PG&E Letter DCL-16-044

Diablo Canyon Units 1 and 2

Response to NRC Request for Additional Information Regarding License
Amendment Request 15-03, "Application of Alternative Source Term"

Pacific Gas and Electric Company (PG&E) Response to NRC Request for Additional Information (RAI) Regarding Diablo Canyon Power Plant (DCPP) License Amendment Request (LAR) 15-03, "Application of Alternative Source Term"

Table RAI-3a-1

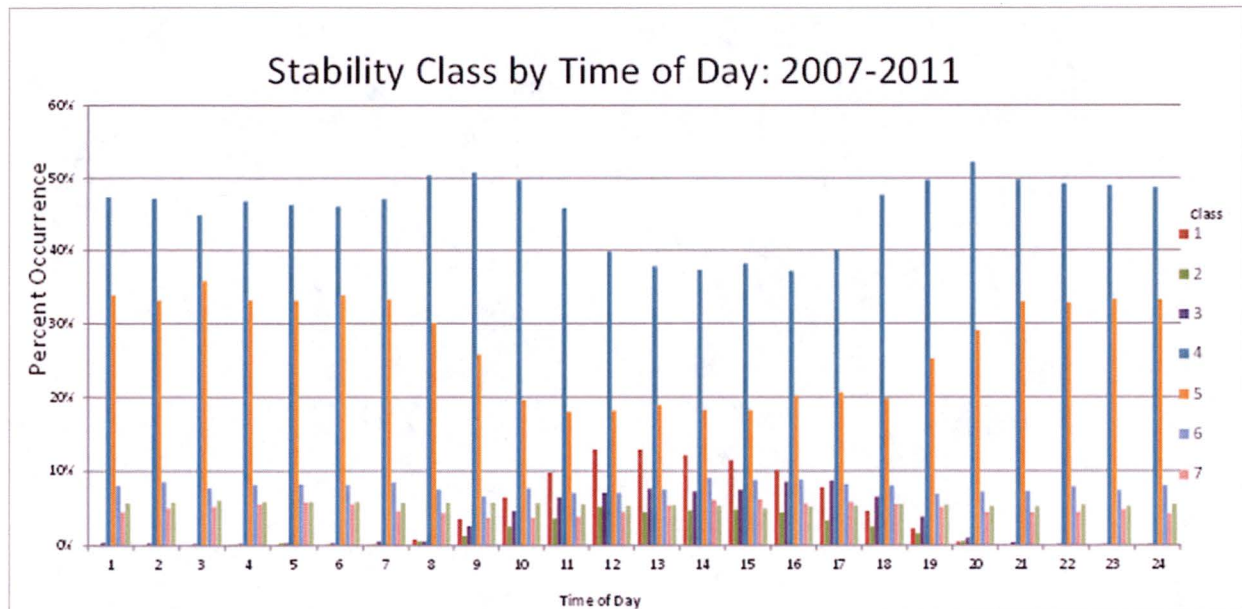
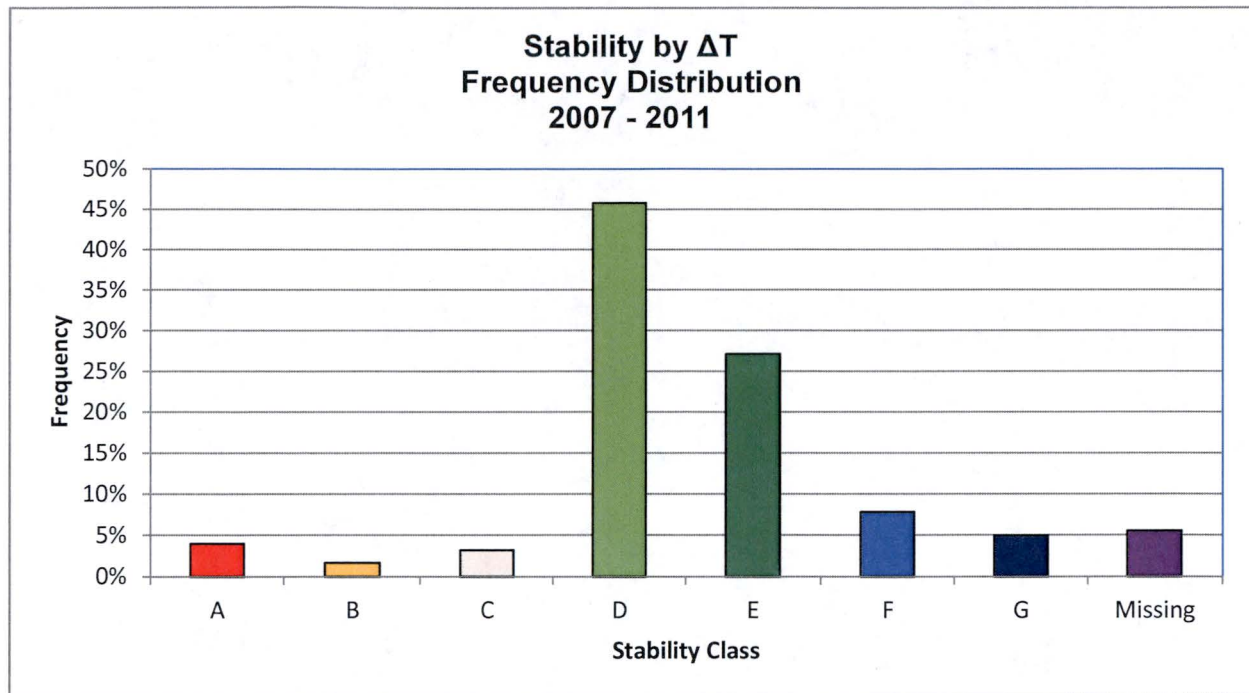
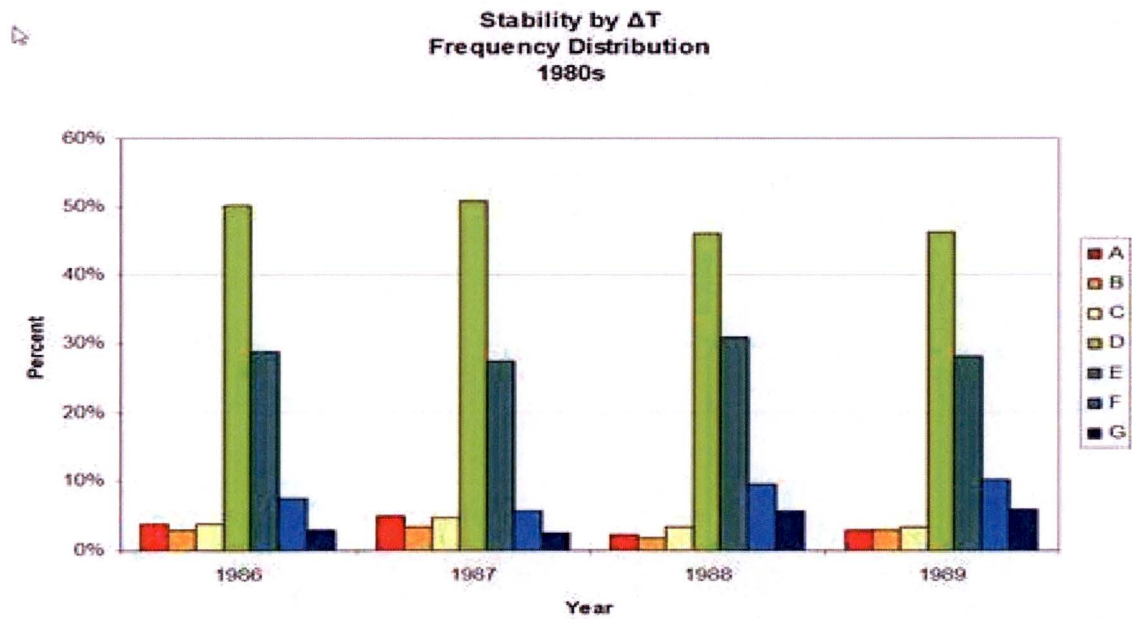
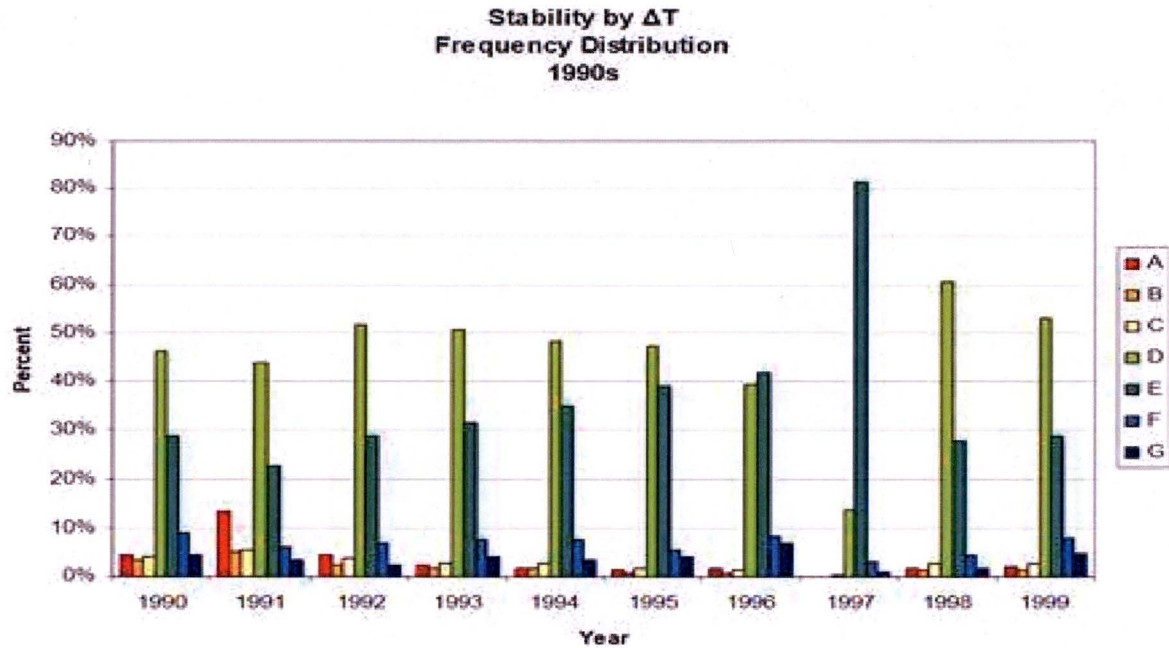
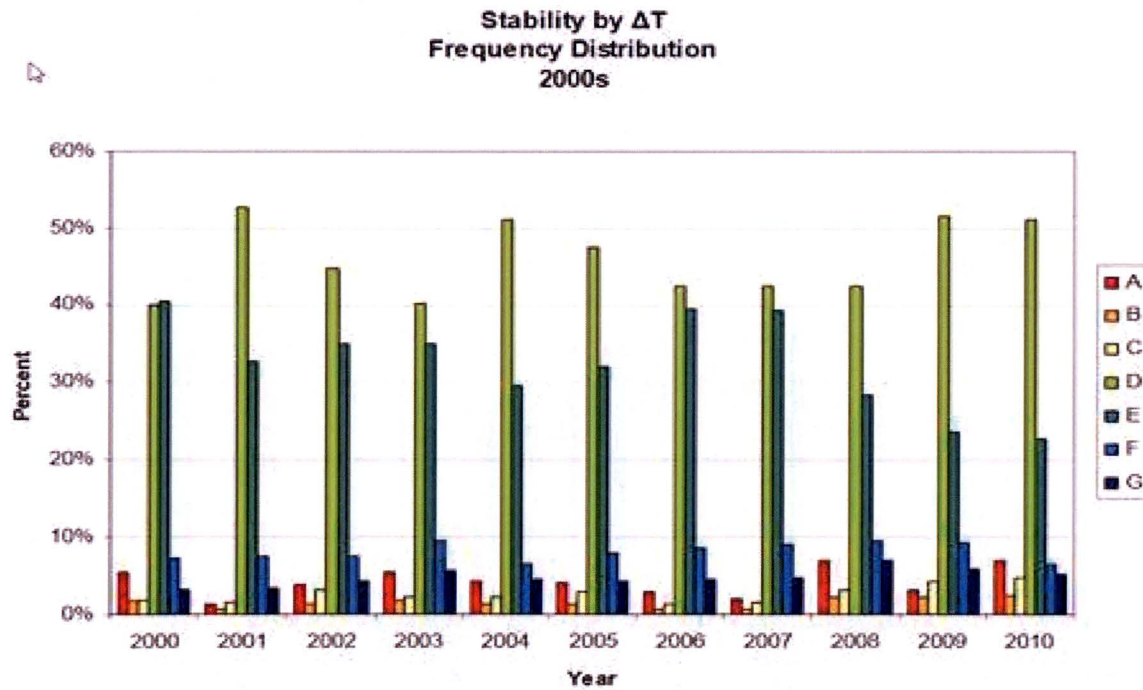
provide technical and climatological justification of these frequencies and durations to establish the validity of these portions of the basic Met data sets;

The apparent unusual persistence of stable atmospheric conditions is a direct result of the marine environment climate where the DCPD primary and backup Met towers are sited, in combination with a high frequency of onshore afternoon sea breeze winds. The Figure below shows the proximity of the primary and backup Met towers to the Pacific Ocean, which, due to upwelling, is cold throughout the year.

This very high persistence of the onshore winds (wind from the cold Pacific Ocean) significantly modifies the effects of surface heating during the day and generates a much higher frequency of stable or neutral conditions during the time of maximum solar heating (i.e., 10 AM – 4 PM) than what occurs at locations farther inland with little to no marine influence. Furthermore, the presence and persistence of summertime coastal low-lying stratus clouds further inhibit surface warming and add to the decrease in the frequency of unstable conditions. Figure RAI-3a-2, based on 2007-2011 RG 1.23 stability class data derived from vertical temperature differences, shows that neutral and slightly stable stability classes are the most frequent due to persistent onshore winds and coastal stratus clouds, but also that unstable conditions (stability classes A, B, and C) increase during the diurnal cycle and occur with a frequency near 20 – 25 percent during the afternoon hours (12 PM – 4 PM).

The 2007-2011 analysis, shown on Figure RAI-3a-3, correlates well with a 1986-2010 stability by Delta T data analysis performed by PG&E meteorologists Clifford and McCarthy shown in Figures RAI-3a-4, RAI-3a-5, and RAI-3a-6. Averaging the data between 1986 and 2010 indicates that 45 percent of the data are Stability Class D (neutral), while 30 percent of the data are Class E (slightly stable). This average of the data between 1986 and 2010 is consistent with the data shown on Figure 3a-3, for years 2007-2011 where approximately 45 percent of the data were Stability Class D and approximately 27 percent of the data were stability Class E. Additionally, Stability Class A, B, and C (very unstable, moderately unstable, and slightly unstable, respectively) each remained below 5 percent, while Stability Class F and G (moderately stable and very stable, respectively) remained below 10 percent throughout the 1986-2010 time period.
